Results of LMSC Ballot on Draft Standard 802.11 D5.0

Resolutions for Comments on Clause 8

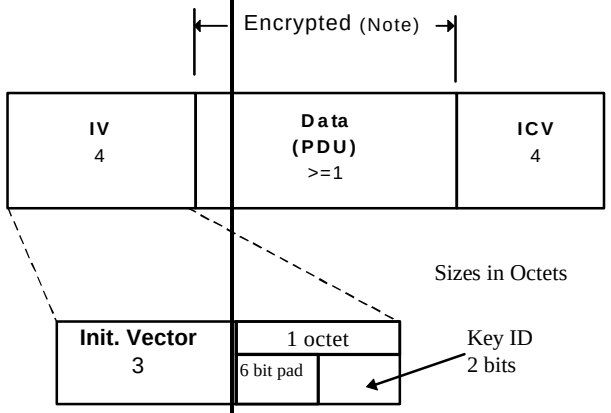
25	**8.2.5 (figure 35)**	**MAF**	**E**	**(na)**	**Text was added to the 2nd paragraph of Clause 8.2.5 at the July 1996 meeting to clarify IV field bit ordering by referring explicitly to the ordering conventions in Clause 7.1.1. However, Figure 35 was not updated to show the key ID bits at the left side of their octet, which is needed for consistency with the order stated in the text: "The key ID occupies the two least significant bits of the last octet of the IV field, while the pad occupies the six most significant bits of this octet."** **(I had to convert the drawing from its original format to "Word 6.0 Picture Object" before Word 6 for the Macintosh would let me edit the drawing. It may be perferable to make equivalnet changes in the original drawing rather than inserting the picture object to the right in place of the existing Figure 35.)**	Replacement for Figure 35 drawing:	**Accepted**
